## Supplementary Bat & Ecology Note

Former Friends School, Saffron Walden

July 2022

**Plate 1.** Building B12 (outlined blue), showing section 1, 2, and 3 with surveyor locations for emergence survey shown in yellow ('A' & 'B')

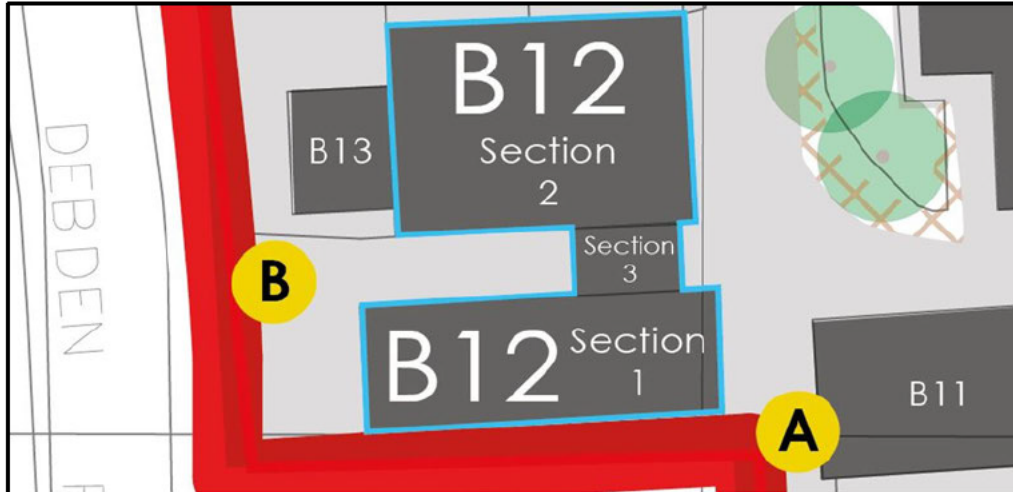
- 1.3 A consultation response letter received from Place Services (20 July 2022) noted "We are still not satisfied that there is sufficient ecological information available for determination of this application. Although we have had clarification on the bat roosting potential of the trees and some of the buildings, we are not satisfied that building B12 has had sufficient coverage during the bat emergence surveys.

*Table E.1 of the Ecological Impact Assessment (CSA Environmental, February 2022), previously reviewed, states that air vents on the eastern and western gables ends of the pitched roof provide potential access points for bats. The roof void of this section of the building was also said to be inaccessible. The Bat Survey Results Plan, drawing number CSA/4017/106 does not show a surveyor covering the western aspect of building B12. The reference to the air vents on the western gable has now been removed from the updated Ecological Impact Assessment (CSA Environmental, June 2022) despite the air vents being present on the western aspect (as seen from Google Street View, accessed July 2022). Justification as to why the western aspect of B12 was not surveyed has not been provided.*

*Further information as to why the western aspect of building B12 was not surveyed or results of appropriate emergence/re-entry surveys, in line with best practice guidance (Collins, 2016), should be provided."*

- 2.16 No bats were recorded to emerge from Building B12 (section 1), with surveyors able to view all elevations of the building. Low numbers of common pipistrelle *Pipistrellus pipistrellus* were recorded during the survey.

- 2.20 Having completed one full nocturnal survey, and covering all elevations, in addition to previous survey work carried out in 2020, it can be **reasonably proven that the building does not support any bat roosts** based upon BCT guidelines.
